# Service Bulletin

Date: March 2004  
Bulletin No: 16 001 04 (002) Revised

Subject: Recall 04V-028, Fuel line connections.  
K and R Series.

Figure #5:

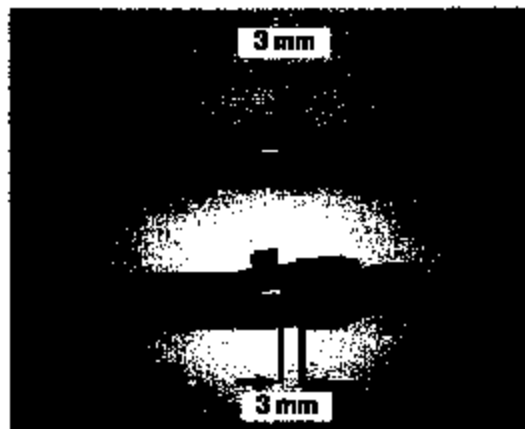
When removing fuel line clamps, we recommend using the tool and position as shown in figure #5.

Figure #6

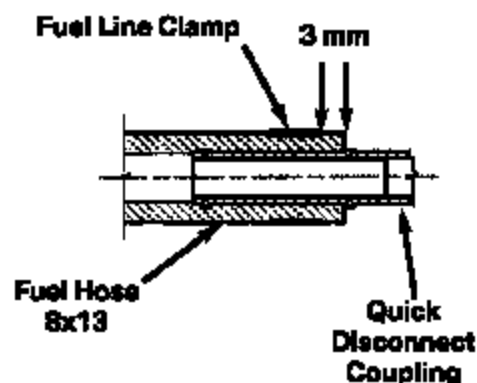
If the fuel line clamp needs to be replaced (see reference to appropriate part numbers in Warranty Reimbursement section), replace the connection hose as well. In completing this operation it is essential to observe the dimensions shown in Figures #6 and #7 on the following page.
